Access Compliance Report

Public Rights-of-Way

(Curb Ramps)

Intersection ID: 23795	Main Street: DOWNS_RD	Cross Street: E WESTINGHOUSE BV	Location: NE
ADA ID: DE5C4C63D673	Ramp Type: Perp	Initial Pass/Fail: Fail	Overall Compliance: No
Codes/Mitigation Info/Possible Solution		Field Measurements/Component Compliance

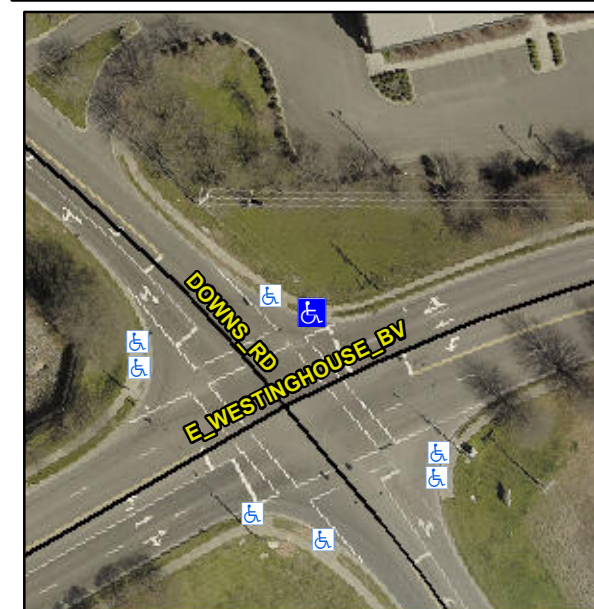
Not Found, R304.2.2, R304.5.3

Compliance	Description	Data	Compliance	Description	Data
N/A	Ramp Length (in)	83.0	No	Ramp Slope (%)	9.6
Yes	Ramp Width (in)	48.0	No	Ramp XSlope (%)	3.9
N/A	Flare Type LT	N/A	N/A	Flare Type RT	N/A
N/A	Flare Slope LT (%)	N/A	N/A	Flare Slope RT (%)	N/A
N/A	Flare Traversable LT?	N/A	N/A	Flare Traversable RT?	N/A
N/A	Landing Length (in)	N/A	N/A	DWS Provided?	N/A
N/A	Landing Width (in)	N/A	N/A	DWS Contrast?	N/A
N/A	Landing Slope (%)	N/A	N/A	DWS Length (in)	N/A
N/A	Landing X Slope (%)	N/A	N/A	DWS Full Width?	N/A
N/A	Landing Curb? (Y/N)	N/A	N/A	DWS Offset (in)	N/A
N/A	Shared Landing?	N/A			
N/A	Gutter Ponding?	N/A	N/A	Gutter Slope (%)	N/A
N/A	Gutter Lip Ht (in)	N/A	N/A	Gutter X Slope (%)	N/A
N/A	Painted X Walk1?	Yes	N/A	Painted X Walk2?	N/A
	X Walk 1 Direction	To S		X Walk 2 Direction	N/A
N/A	X Walk 1 Width (in)	98.0	N/A	X Walk 2 Width (in)	N/A
	X Walk 1 Slope (%)	2.5		X Walk 2 Slope (%)	N/A
	X Walk 1 X Slope (%)	3.1		X Walk 2 X Slope (%)	N/A

N/A	Ramp inside XWalk1?	No	N/A	Ramp inside XWalk2?	N/A
	Road Slope (%)	N/A	N/A	Clear Space?	N/A
	Road X Slope (%)	N/A	N/A	Clear Space to XWalk (in)	N/A
N/A	Any Obstructions?	N/A	N/A	Storm Grate/Utility Hazard?	N/A
	Obstruction Type			Storm Grate/Utility Type	
		N/A			N/A
			Yes	Surface Condition? (G/P)	Good

**Remove & Replace Entire Ramp.
Restripe Crosswalk.**
